Mecklenburg County
Health Department

Re: Munson Hill Road
File: 1554B
Parcel: 217-201-24PO

Receipt of the plans and specifications for a conventional system of sewage treatment and disposal for the above property is hereby acknowledged. Upon receipt of the information, a review was made of the material on file and a site evaluation was conducted. The plan was then reviewed in conjunction with provisions of 15A NCAC 18A .1900, "Laws and Rules for Sewage Treatment and Disposal Systems." Our comments are listed below (see enclosed soil report):

SOIL/SITE EVALUATION
for ON-SITE WASTEWATER SYSTEM

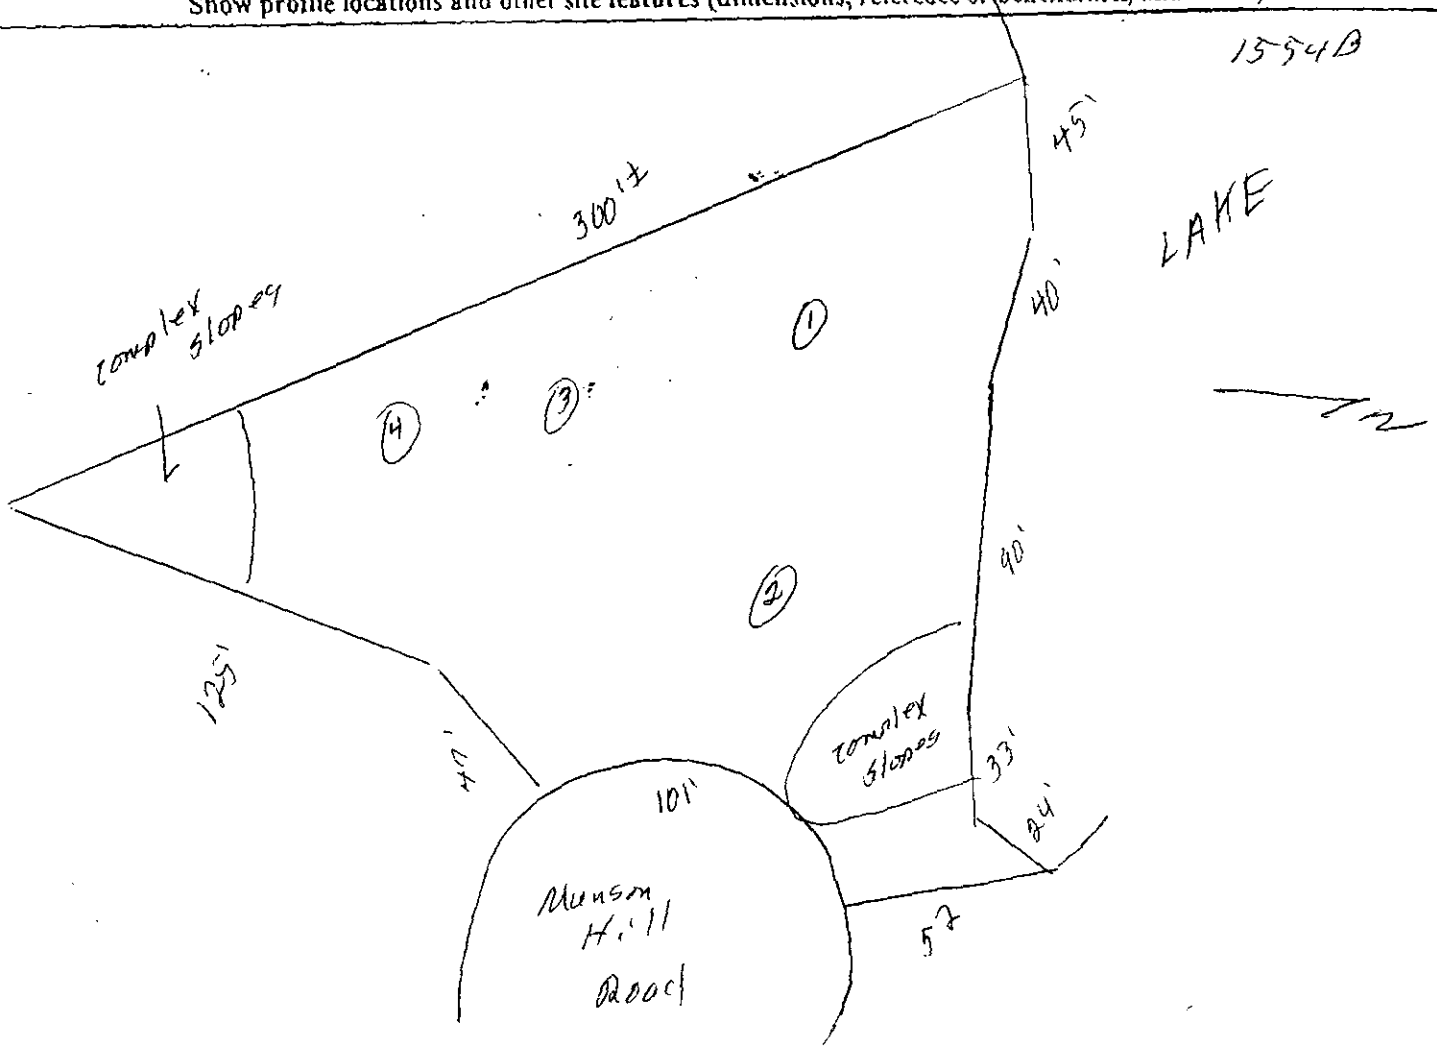
1- The available area on this site is classified as **UNSUITABLE** according to the following rules:

(a) .1940 Topography and Landscape Position
(b) .1943 Soil Depth
(c) .1945 Available Space

For these reasons, the plans as submitted are disapproved.

Possible ways to develop this site includes submittal of a plan for a Low Pressure System. These plans would also need to include appropriate surface water diversions. Enclosed is a copy of Rule .1956 Modifications to Septic Tank Systems pertaining to Low Presure Systems. This system is required to have a management entity contract. This would also require a design plan from an individual with a working knowledge of septic systems. This plan would be submitted to this office for review, and if it is determined that the system can function properly, an Improvement Permit will be issued by the Department upon completion by you of a formal requisition for lot reclassification.
